**Economic and Social Council**Distr.: General
22 July 2024

Economic Commission for Europe**Inland Transport Committee****World Forum for Harmonization of Vehicle Regulations****Working Party on General Safety Provisions****128th session**

UN Regulation No. 39 (Speedometer and Odometer)**Proposal for the 02 Series of Amendments to UN Regulation No. 39 (Uniform Provisions concerning the Approval of Vehicles with regard to the Speedometer and Odometer Equipment Including its Installation)****Submitted by the Task Force on UN Regulation No. 39 covering mileage values ***

Model A

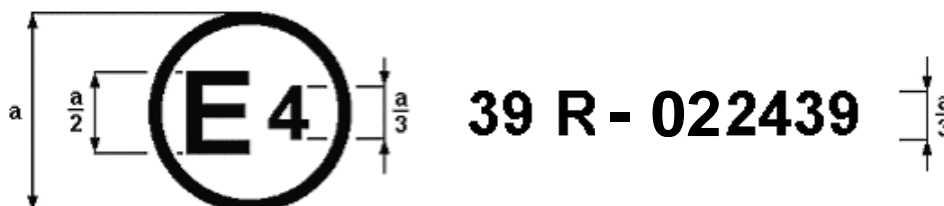
The above approval mark affixed to a vehicle shows that the vehicle type concerned has been approved in the Netherlands (E 4), pursuant to Regulation No. 39. The approval number indicates that the approval was granted in accordance with the requirements of UN Regulation No. 39 incorporating the ~~01~~02 series of amendments.
